P 42853

SEWAGE DISPOSAL SYSTEM

A REPAIR

ADDRESS 10459 Frederick Road, Ellicott City, MD 21043 PHONE 465-1028

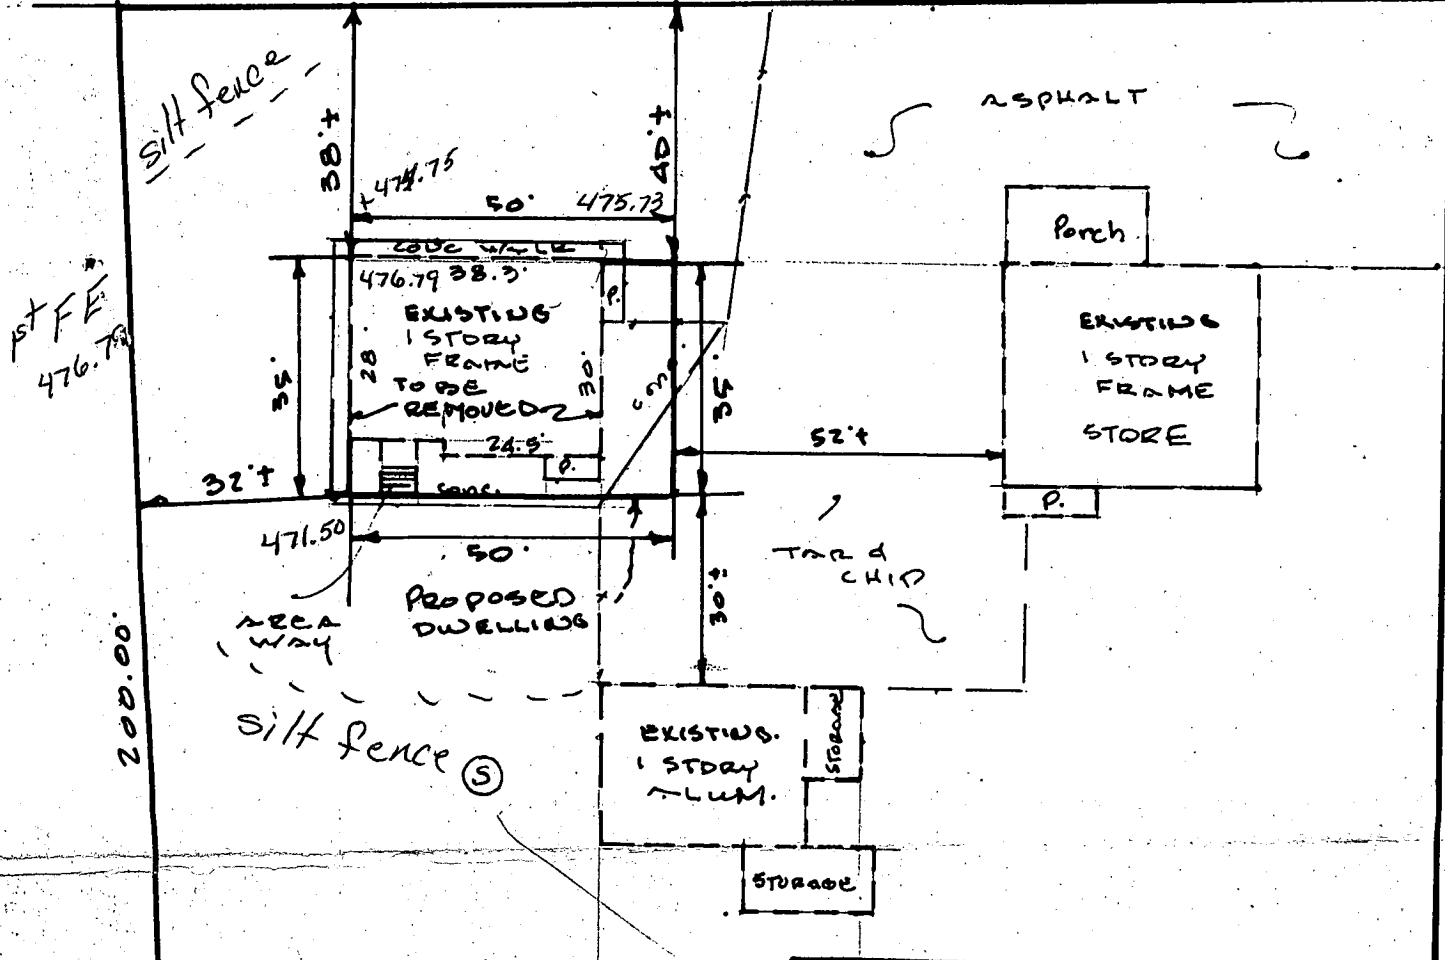
REMARKS 6/27 SEPTIC TANK TO BE INSPECTED AND REPAIRED AS REQ'D.

TEST HOLE 1 MARGINAL DEEP CLAY, WATER TABLE. // TEST HOLE 2 BETTER OK 2-11'

INSTALL LEACHING BED BETWEEN TANK AND TEST HOLE 2. ABANDON EXISTING DRYWELL

WHICH PENETRATES WATER TABLE. INSTALL 3'-4' OF STONE IN LEACHING BED, KEEP

10' FROM DRYWELL; AS CLOSE TO 500' SQ FT BOTTOM AREA AS POSSIBLE. 6/27/89 CW

6/27/89 TANK IN GOOD REPAIR - LEACHING BED INSTALLED - OK TO COVER. CW
